CNL-16-159

Watts Bar Nuclear Plant, Unit 2
Facility Operating License No. NPF-96
NRC Docket No. 50-391

Subject: **Application to Modify Watts Bar Nuclear Plant Unit 2 Technical Specifications to Extend Surveillance Requirement (SR) Intervals for SRs 3.6.11.2 and 3.6.11.3 (WBN-TS-16-022)**

Figure 1 Predicted Sublimation using UFSAR Sublimation Rates

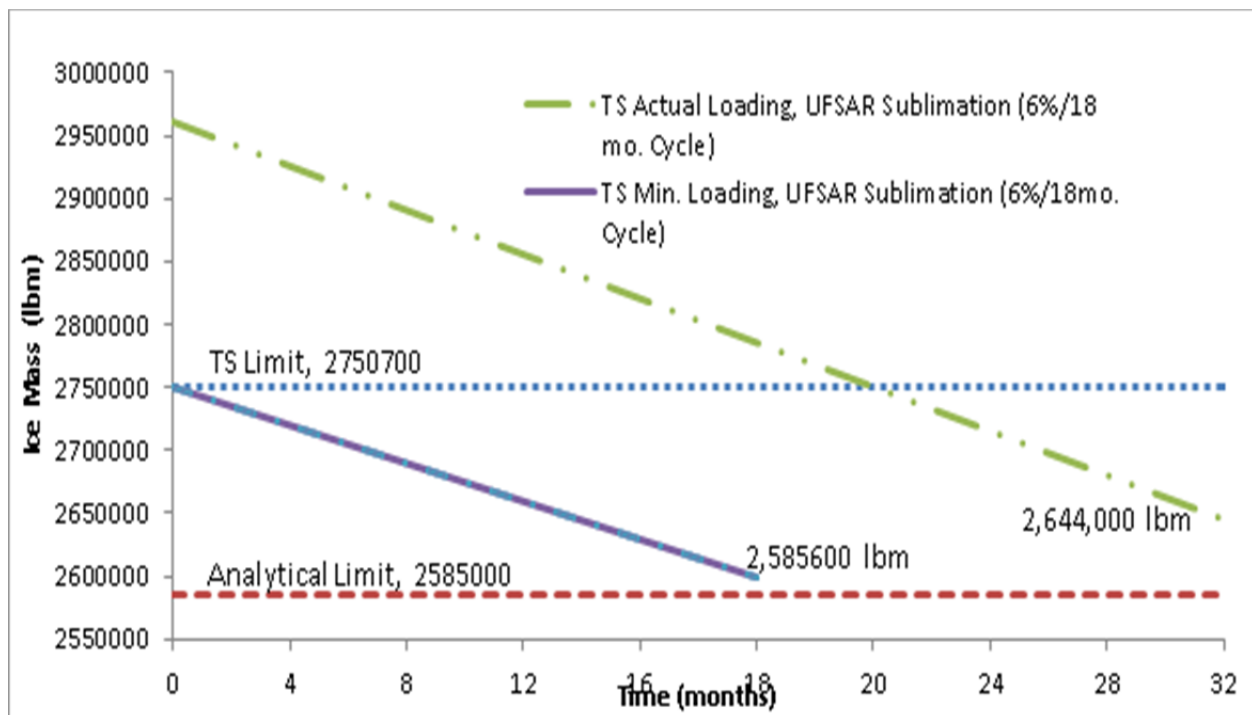
At the 6% per cycle sublimation rate assumed in the UFSAR, the TS 3.6.11 minimum ice mass is intended to provide sufficient ice to last for a typical 18-month fuel cycle, as shown in Figure 1. The first WBN Unit 2 fuel cycle is currently planned for October 2017, which is approximately 32 months from the initial ice weighing surveillance that was initiated on March 17, 2015.

The below calculation shows that 10.7% of the ice would be lost due to sublimation over the proposed extended cycle using the 6% UFSAR sublimation assumption. The use of a simplified linear sublimation rate is considered adequate, given the fact that actual sublimation is half of the assumed sublimation.

Due to the conservatism involved in the planning of the ice loading, the initial WBN Unit 2 ice bed was not loaded to the TS 3.6.11 minimum, but instead was loaded to the significantly higher weight of 2,961,620 lb. Applying the calculated 10.7% sublimation to this ice weight, at the end of the extended operating cycle, the ice bed would still contain approximately 2,644,000 lb of ice. As shown in Figure 1, this is approximately 59,000 lb above the analytical limit required for the design basis LOCA.
